PRODUCT/PROCESS CHANGE NOTICE (PCN)

PCN #: **A1208-02** Date: September 6, 2012
Product Affected: LQFP-144

PCN Type: Change of Assembly Location & Exposed Pad Dimension

Exposed Pad Dimension Change

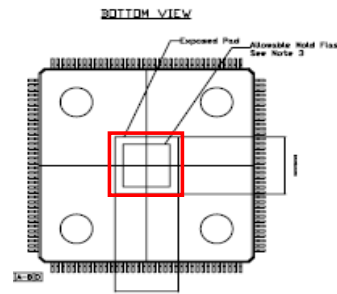
In relation to this assembly location change, the exposed pad dimension will also change from 5.9mm to 6.4mm. Refer attachment for package outline drawing.

New - 6.4mm
(Refer to attached package drawing dimension D2 / E2)

Old - 5.9mm
